RE: Notice to Suspend and Intent to Terminate Contract for SW 2nd Avenue Median Parking, Invitation to Bid No.12278-693, Project No. 12434

NOTICE OF FINAL PUNCH LIST AND DEFECTIVE ITEMS

FINAL SITE INSPECTION REPORT

PROJECT # 12434
 SW 2ND AVENUE PARKING
 IMPROVEMENTS BETWEEN SW 32ND ST & SW 30TH ST
 PAVING GRADING & DRAINAGE PLAN

Item "c"

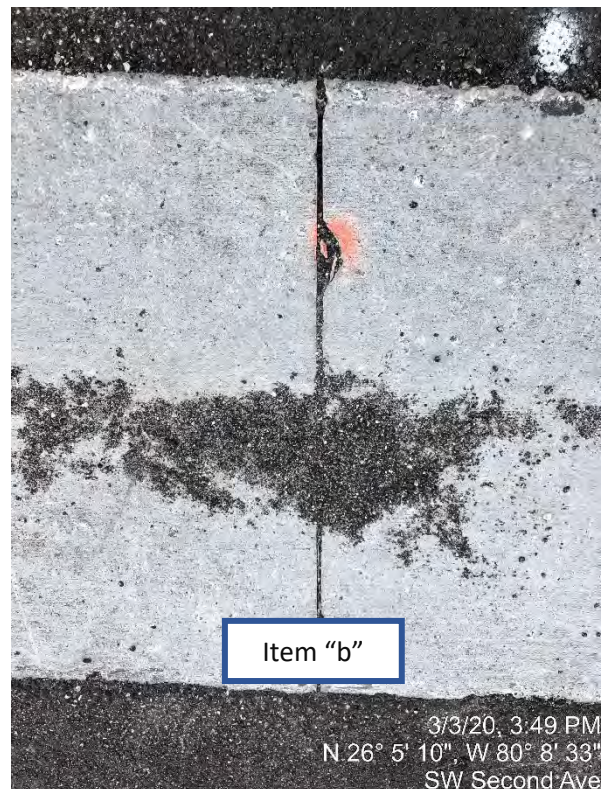
- a. Oil stains recorded on parking spaces No. 1, No. 2, and No. 8 from North to South STA 26+00 to STA 26+30, and STA 25+40.
- b. Ponding recorded on parking spaces No. 1, No. 2, No. 3, No. 4, and No. 8 from North to South (STA 26+25 to STA 25+85, and STA 25+30 respectively).
- c. CONTRACTOR failed to test for conformity with the specified grade after initial compression. Variance in surface more than 1/8-inch from the lower edge of a 12-foot straightedge recorded on parking space No. 8 from North to South STA 25+30.

Item "a"

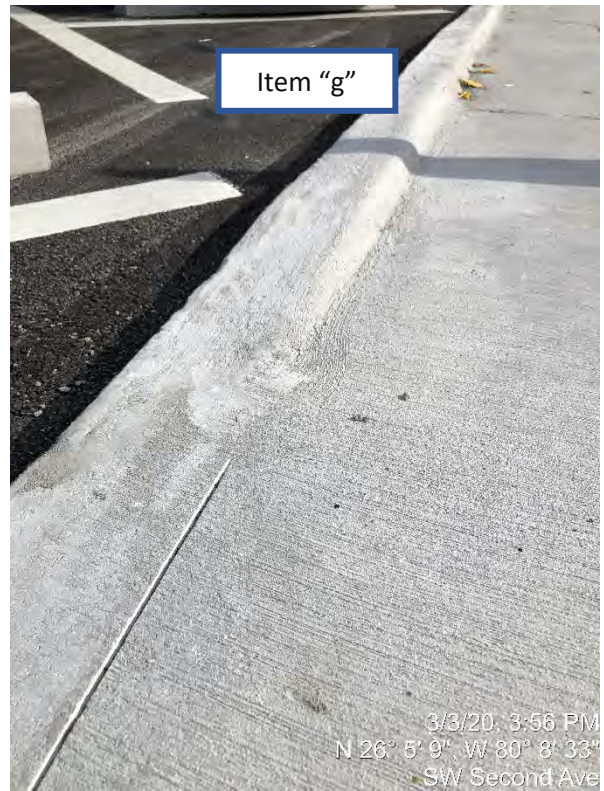
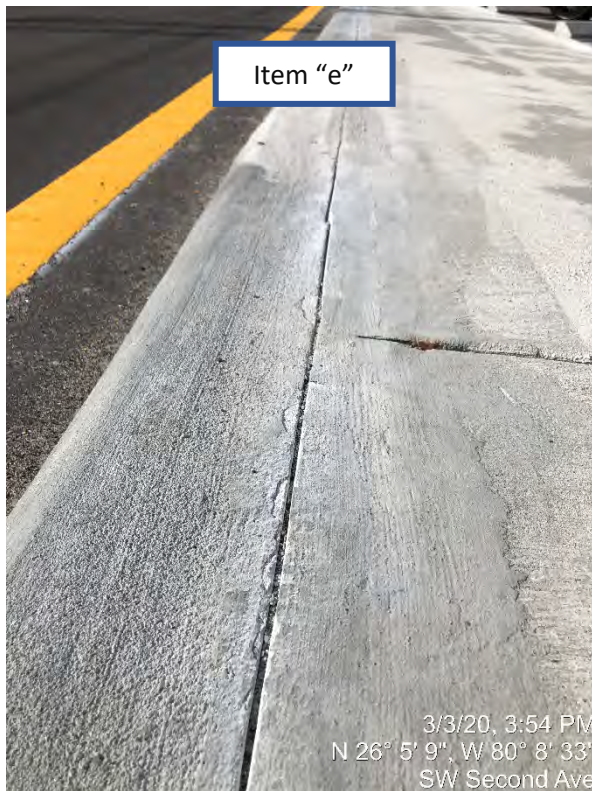
- a. Crack(s) recorded at Concrete Sidewalk STA 25+64 (4th joint North of ADA detectable warning surface).
- b. Crack(s) recorded at Concrete Sidewalk STA 25+69 (5th joint North of ADA detectable warning surface).

- c. Grinding of concrete at Valley Gutter STA 26+26 (North of catch basin No. 1 inlet).
- d. Crack(s) recorded at Valley Gutter STA 26+19 (South of catch basin No. 1 inlet).

- e. Deficient Valley Gutter Concrete/Asphalt interface STA 25+92 (3rd joint South of inlet of catch basin No. 1).
- f. Crack(s) recorded at Valley Gutter STA 25+39 (1st joint from South to North).

- g. Crack(s) recorded at Valley Gutter STA 25+49 (2nd joint from South to North).
- h. Joint missing and crack(s) recorded at Valley Gutter STA 25+30 (convergence of Valley Gutter and Type F Curb).

- i. Incorrect jointing pattern recorded on Concrete Sidewalk STA 25+25 to 26+33 (entire median).
- j. Ponding recorded on Concrete Sidewalk flags No. 1, No. 4, and No. 9 from North to South (STA 26+10, STA 25+95, and STA 25+35 respectively).

- k. Crack(s) recorded on curved portion of Type D Curb STA 25+05.

Median No. 2 (STA 26+15 – STA 27+65)

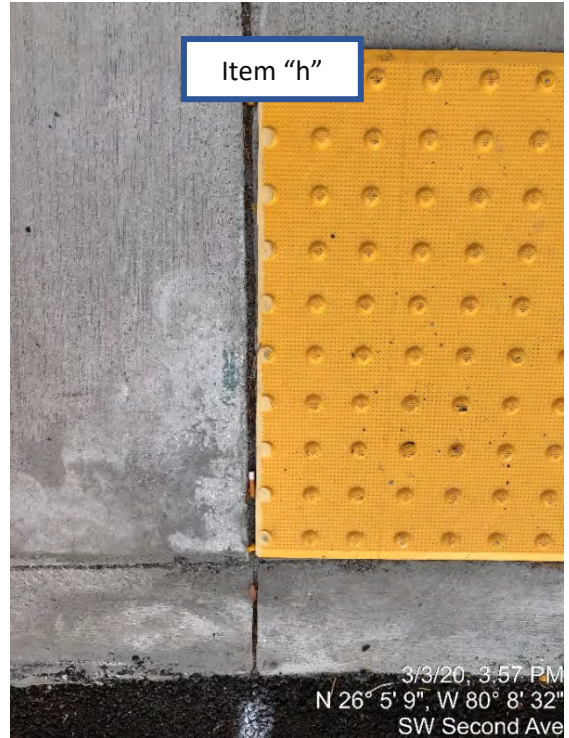
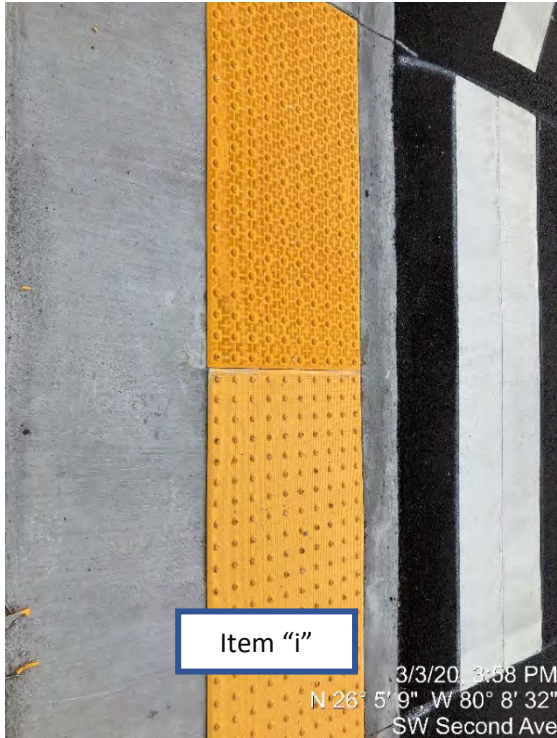
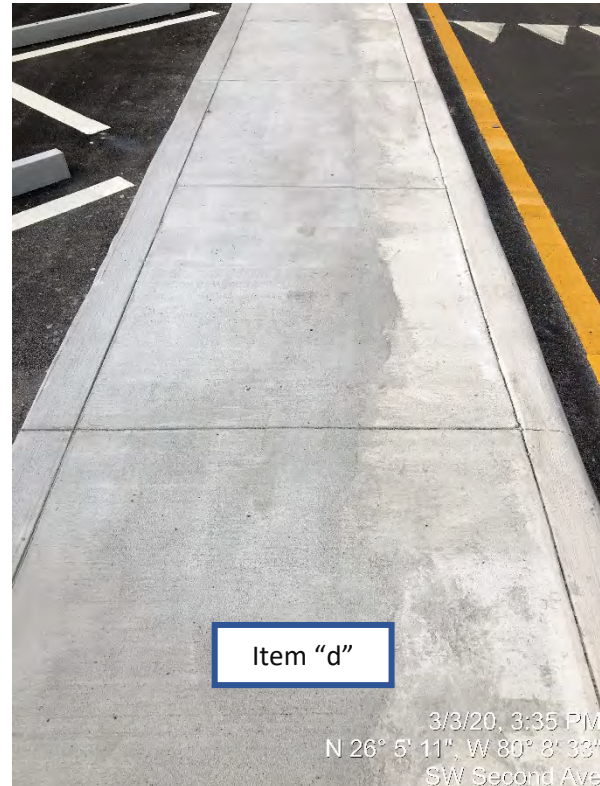
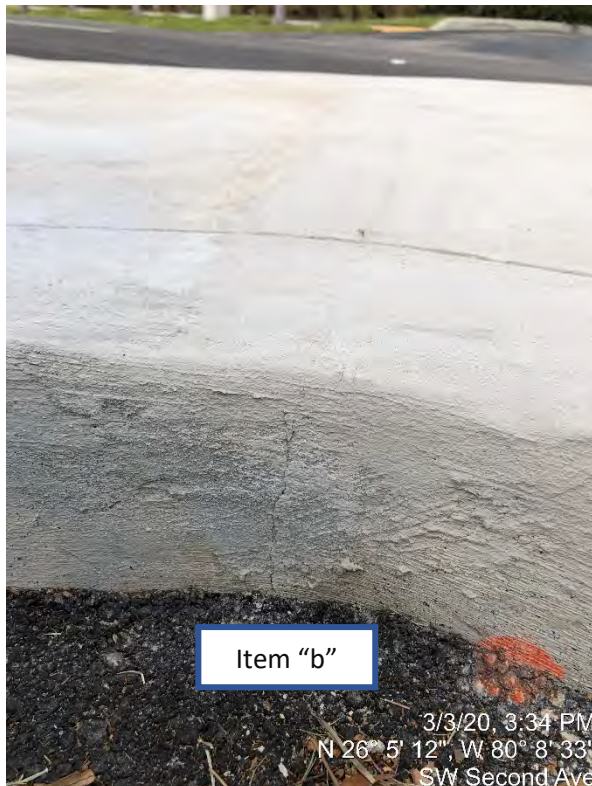
- a. Grinding of concrete at Valley Gutter STA 27+40 (convergence of Valley Gutter and Type F Curb).
- b. Crack(s) recorded at Valley Gutter STA 27+30 (1st joint from North to South).

- c. Concrete Wheel Stop damaged STA 26+49 (2nd from South to North).
- d. Concrete Wheel Stop inadequately installed 27+45 (1st from North to South).
- e. Repair method was not reviewed/approved by the City and it shows poor finish on Type D Curb STA 26+33 to STA 27+43. (deficiencies recorded at both sides of Concrete Sidewalk).

- f. Incorrect jointing pattern recorded on Concrete Sidewalk STA 26+33 to STA 27+43 (entire median).
- g. Expansion joint between Concrete Sidewalk and Type D Curb is interrupted at ADA accessible route ramp STA 26+62.

- h. Concrete grinding and/or poor finish on Concrete Sidewalk STA 26+67. (North and against detectable warning surface).
- i. Mismatch of detectable warning surfaces recorded STA 26+62.

- j. Ponding recorded on Valley Gutter STA 27+40 to STA 27+10. Low elevation grade at North end of Valley Gutter.
- k. Ponding recorded on Concrete Sidewalk flags No. 2, No. 3, and No. 5 from North to South (STA 27+35 to STA 27+25, and STA 27+15 respectively).

- l. Ponding recorded on Concrete Sidewalk behind detectable warning surface STA 26+63.
- m. Trip hazard between Type D Curb and Concrete Sidewalk STA 26+62.

- a. Ponding recorded behind Wheel Stops of parking spaces No. 2 and No. 8 from North to South STA 27+31 and STA 26+54 respectively.
- b. Ponding recorded on parking spaces No. 1 and No. 10 from North to South STA 27+39 and 26+33 respectively.

Median No. 3 (STA 28+40 – STA 29+85)

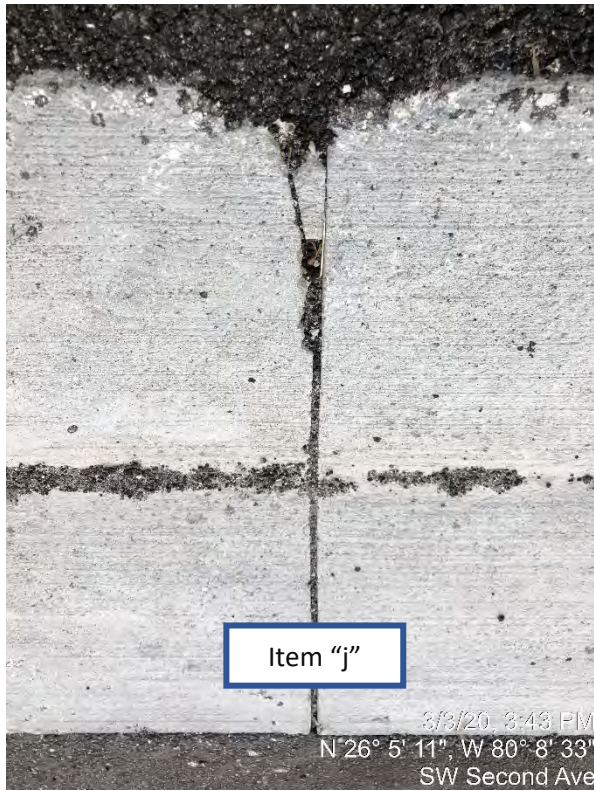
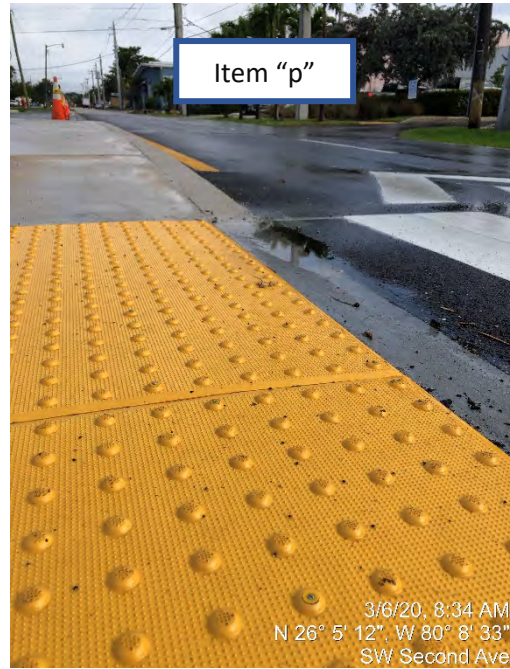
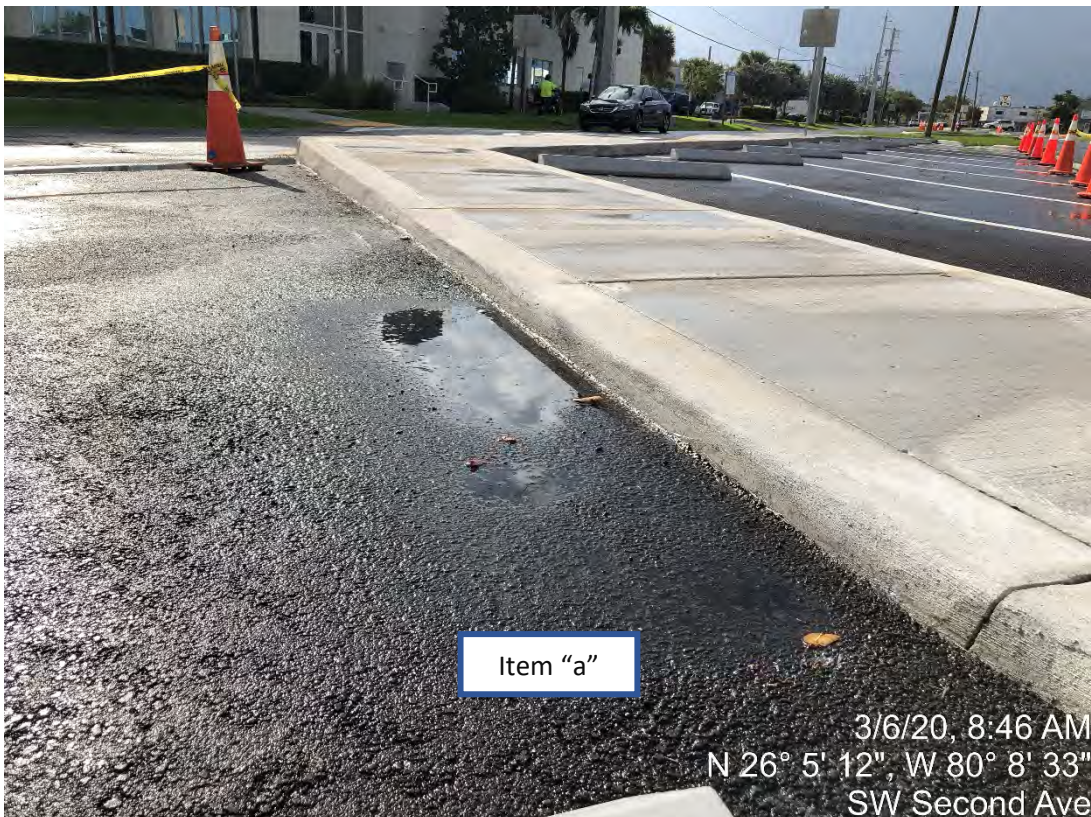
- a. Crack(s) recorded at Valley Gutter STA 29+82 (convergence of Valley Gutter and Type F Curb).
- b. Repair method was not reviewed/approved by the City and it shows poor finish on Type D Curb STA 29+66 to STA 29+85.

- c. Crack(s) repair method was not reviewed/approved by the City and it shows poor finish on Concrete Sidewalk STA 29+66.
- d. Repair method was not reviewed/approved by the City and it shows poor finish on Concrete Sidewalk STA 26+05 to STA 28+65.

- e. Expansion joint between Concrete Sidewalk and Type D Curb is interrupted at ADA accessible route ramp STA 29+31.
- f. Crack(s) repair method was not reviewed/approved by the City and it shows poor finish on Concrete Sidewalk STA 29+24 to STA 29+42 (ADA accessible route ramps and landing).

- g. Crack(s) recorded at Type F Curb STA 28+45 (two locations on the curved portion of the curb).
- h. Grinding of concrete recorded at catch basin No. 4 pad STA 28+62.

- i. Crack(s) and grinding recorded at Valley Gutter STA 28+76 (1st joint from South to North).
- j. Crack(s) recorded at Valley Gutter STA 28+85 (2nd joint from South to North).

- k. Incorrect jointing pattern recorded on Concrete Sidewalk STA 28+65 to STA 29+85 (entire median).
- l. Crack(s) recorded at Valley Gutter STA 29+82 (1st joint from North to South).

- m. Trip hazard between Type D Curb and Concrete Sidewalk STA 29+50.
- n. Expansion joints on curved portion of Type D Curb are irregular and not beveled.

- o. Ponding recorded throughout the Valley Gutter STA 28+67 to STA 29+54 and at STA 29+84 (North end). Low elevation grade recorded at both ends of Valley Gutter.

- p. Ponding recorded on Concrete Sidewalk behind detectable warning surface STA 29+34, and at flags No. 12 and No. 13 South of ADA accessible route ramp (STA 28+67 to STA 28+77).

- a. Ponding recorded on Concrete Sidewalk between medians III and IV (STA 29+65 to STA 29+84)
- b. Oil stains recorded on parking spaces No. 3, No. 6, and No. 7 from North to South (STA 29+43, STA 29+95, and STA 29+12 respectively).
- c. Ponding recorded on parking spaces No. 5, No. 6, No. 8, and No. 9 (STA 29+05 to STA 29+30, and STA 28+60 to STA 28+90).
- d. CONTRACTOR failed to test for conformity with the specified grade after initial compression. Variance in surface more than 1/8-inch from the lower edge of a 12-foot straightedge recorded on parking spaces No. 2, No. 6, and No. 8 from North to South STA 29+67, STA 29+06, and STA 28+88.

Median No. 4 (STA 29+64 – STA 31+08)

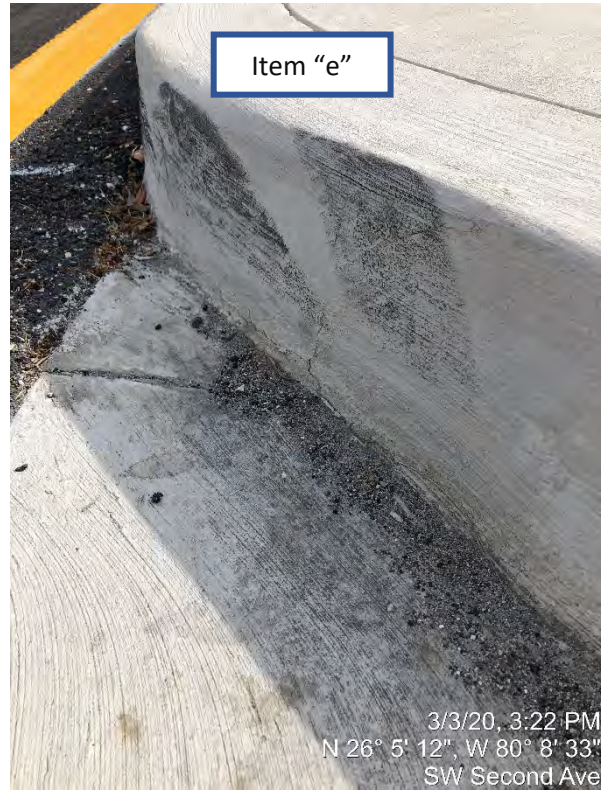
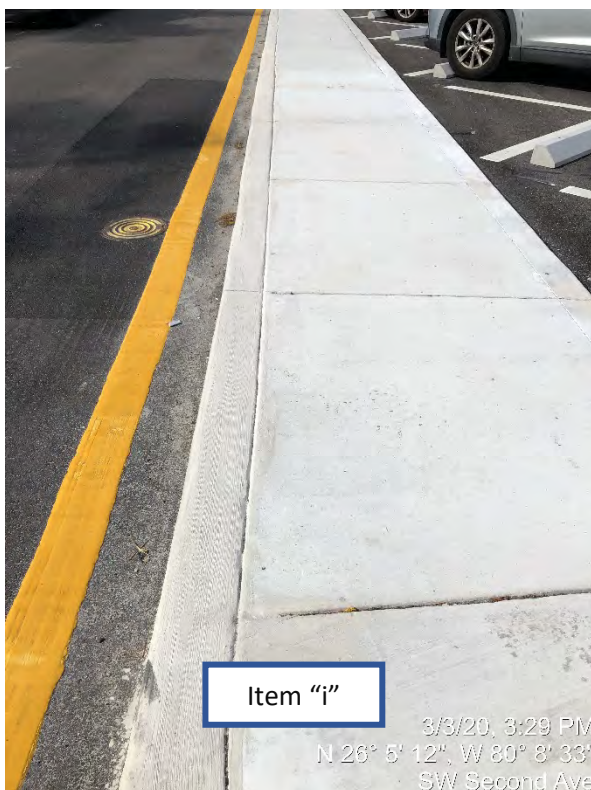
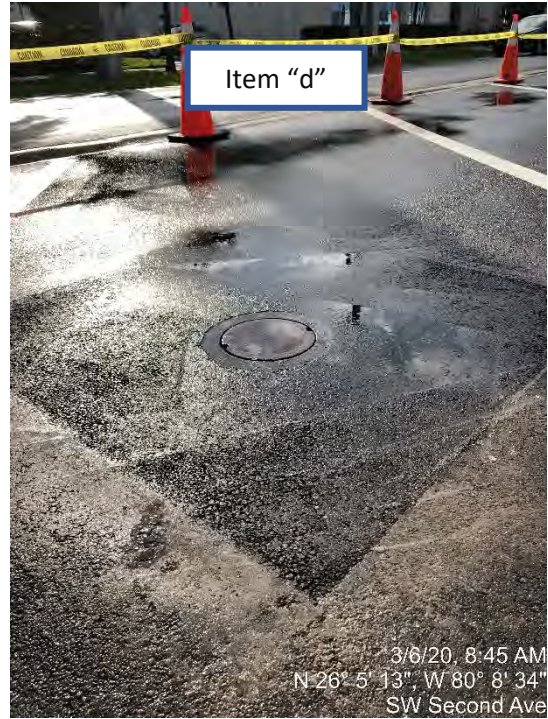
- a. Expansion joints on curved portion of Type D Curb are not beveled.
- b. Crack(s) recorded at Type D Curb STA 30+94 (West side of curb).
- c. Crack(s) and low elevation grade recorded on Type F Curb STA 30+83 (convergence of Valley Gutter and Type F Curb).

- d. Grinding of concrete at Valley Gutter STA 30+29 and STA 30+66
- e. Crack(s) and low elevation grade recorded at Valley Gutter STA 29+67 (beginning of Valley Gutter).

- f. Grinding of concrete at Sidewalk STA 30+82 (1st flag from North to South)
- g. Incorrect jointing pattern recorded on Concrete Sidewalk STA 29+85 to STA 30+85 (entire median).

- h. Crack(s) repair method was not reviewed/approved by the City and it shows poor finish on Type D Curb STA 29+85 to STA 30+65.
- i. Crack(s) repair method was not reviewed/approved by the City and it shows poor finish on Concrete Sidewalk and Type D Curb STA 29+88 (1st joint from South to North).

- j. Ponding recorded throughout the Valley Gutter STA 29+66 to STA 30+83. Low elevation grade recorded at both ends of Valley Gutter.
- k. Ponding recorded on Concrete Sidewalk behind detectable warning surface STA 30+71, and at flags No. 2, No. 7, No. 9, and No. 12 South of ADA accessible route ramp (STA 30+56, STA 30+24, 30+15, and STA 30+00 respectively).

- l. Trip hazard between Type D Curb and Concrete Sidewalk STA 30+71.

- a. Ponding recorded behind Wheel Stops of parking spaces No. 2 and No. 3 from North to South STA 30+58 to STA 30+76.
- b. Ponding recorded behind Wheel Stops of parking spaces No. 5 and No. 6 from North to South STA 30+22 to STA 30+45.
- c. Ponding recorded on SW 2nd Avenue Southbound lane STA 30+85.
- d. Ponding recorded on parking space No. 5 from North to South due to irregular asphalt patch surrounding gas valve STA 30+31.
- e. Ponding recorded on parking space No. 9 from North to South against Type D Curb STA 29+76.
- f. CONTRACTOR failed to test for conformity with the specified grade after initial compression. Variance in surface more than 1/8-inch from the lower edge of a 12-foot straightedge recorded on parking space No. 2 from North to South STA 30+68.

DRAWING # PGD-17
 SHEET 16
 TOTAL: 16
 CAD FILE: 12434-PGDP
 DRAWING FILE NO: 4-141-42

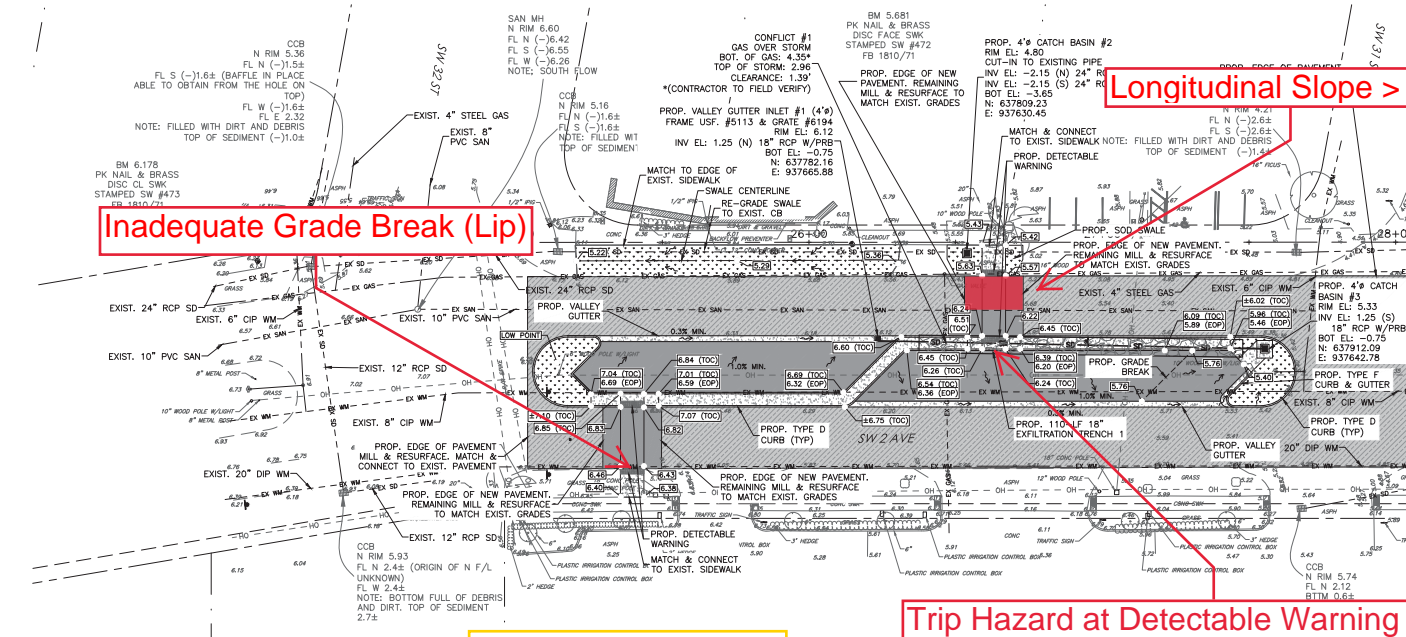
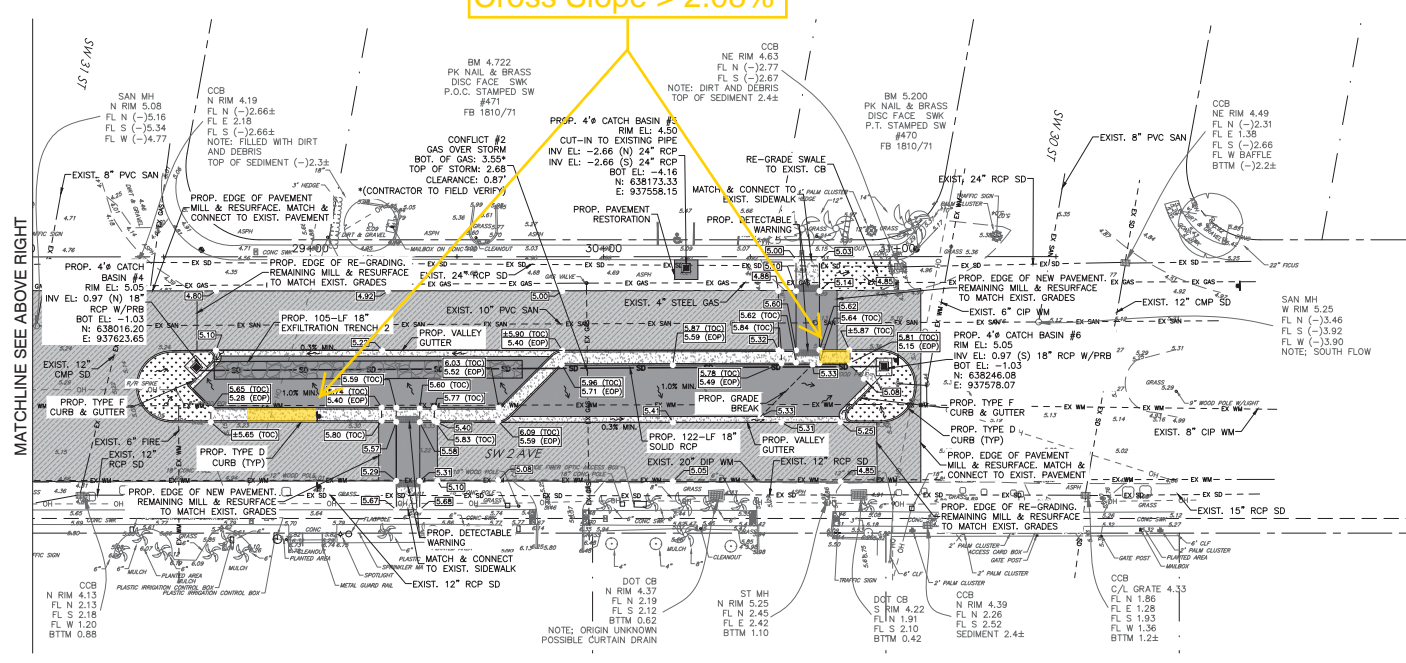
CONTRACTOR failed to comply with ADA cross slope of accessible routes walking surfaces requirements. The cross slope of walking surfaces shall not be steeper than 1:48 (2.08%). Portions of the sidewalk cross slope within the North median of SW 2nd Avenue were measured and recorded to be out of compliance.

Changes in level between ¼ inch and ½ inch shall be beveled with a slope not steeper than 1:2. CONTRACTOR failed to install detectable warning surfaces flushed with the abutting concrete sidewalks.

CONTRACTOR failed to comply with ADA running slope of accessible routes walking surfaces requirements. The running slope cannot exceed 1:20 (5%). The South raised crosswalk of SW 2nd Avenue Southbound right lane longitudinal slope is greater than 5%. The slope was measured at 7.5% - 8%, which represents a rise of approximately 9-inches in a 10-foot run.

Portions of accessible routes with running slopes steeper than 5% must be treated as ramps as prescribed in the ***United States Access Board Guideline – Chapter 4: Ramps and Curb Ramps***. Ramps running slope cannot exceed 1:12 (8.33%). Ramps must be equipped with handrails at both sides if rise is greater than 6 inches.

CONTRACTOR failed to provide adequate grade break or smooth transitioning between raised crosswalk and concrete sidewalk. Uneven surfaces were identified on the South raised crosswalk of SW 2nd Avenue Northbound right lane grade break with existing sidewalk. No lips or other variations in slope within runs are allowed, as they can disrupt wheelchair travel.

Portions of accessible routes with running slopes steeper than 5% must be treated as ramps. Handrails must be provided on both sides if rise is greater than 6"

Corrective actions shall be submitted and approved by the CITY before being performed. Grinding of the concrete surface is not acceptable as it may expose the concrete aggregates, compromising the durability of the structure.
